# Access Compliance Report

## Public Rights-of-Way

Intersection ID: 5713	Main Street: RIDGE_ACRES_RD	Cross Street: TRAILING_ROCK_DR	Location: SE
ADA ID: CBB4AE5F44D7	Ramp Type: PerpDiag	Initial Pass/Fail: Fail	Overall Compliance: No
Severity Score: 22.5			
Codes/Mitigation Info/Possible Solution		Field Measurements/Component Compliance

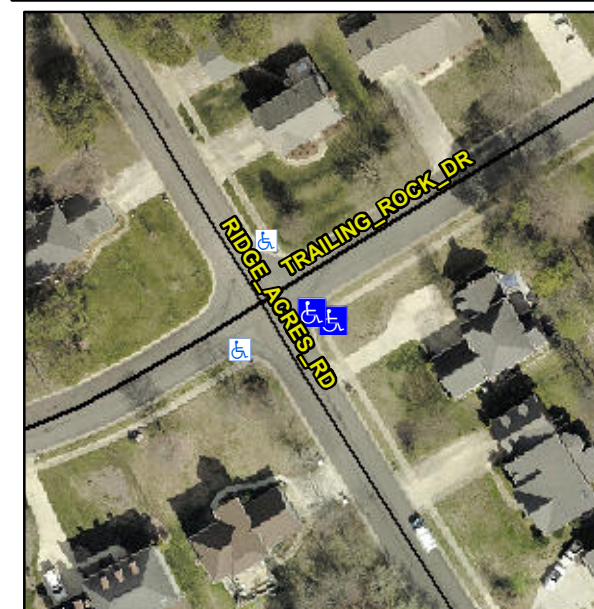
**Not Found, R304.5.1, R304.2.2, R304.5.3**

Compliance	Description	Data	Compliance	Description	Data
N/A	Ramp Length (in)	53.0	No	Ramp Slope (%)	8.8
No	Ramp Width (in)	45.5	No	Ramp XSlope (%)	3.3
N/A	Flare Type LT	N/A	N/A	Flare Type RT	N/A
N/A	Flare Slope LT (%)	N/A	N/A	Flare Slope RT (%)	N/A
N/A	Flare Traversable LT?	N/A	N/A	Flare Traversable RT?	N/A
N/A	Landing Length (in)	N/A	N/A	DWS Provided?	N/A
N/A	Landing Width (in)	N/A	N/A	DWS Contrast?	N/A
N/A	Landing Slope (%)	N/A	N/A	DWS Length (in)	N/A
N/A	Landing X Slope (%)	N/A	N/A	DWS Full Width?	N/A
N/A	Landing Curb? (Y/N)	N/A	N/A	DWS Offset (in)	N/A
N/A	Shared Landing?	N/A			
N/A	Gutter Ponding?	N/A	N/A	Gutter Slope (%)	N/A
N/A	Gutter Lip Ht (in)	N/A	N/A	Gutter X Slope (%)	N/A
N/A	Painted X Walk1?	No	N/A	Painted X Walk2?	No
	X Walk 1 Direction	To N		X Walk 2 Direction	To W
N/A	X Walk 1 Width (in)	N/A	N/A	X Walk 2 Width (in)	N/A
	X Walk 1 Slope (%)	1.3		X Walk 2 Slope (%)	4.5
	X Walk 1 X Slope (%)	2.5		X Walk 2 X Slope (%)	0.2

**Remove & Replace Curb Ramp With Two New Directional Ramps or Equivalent.**
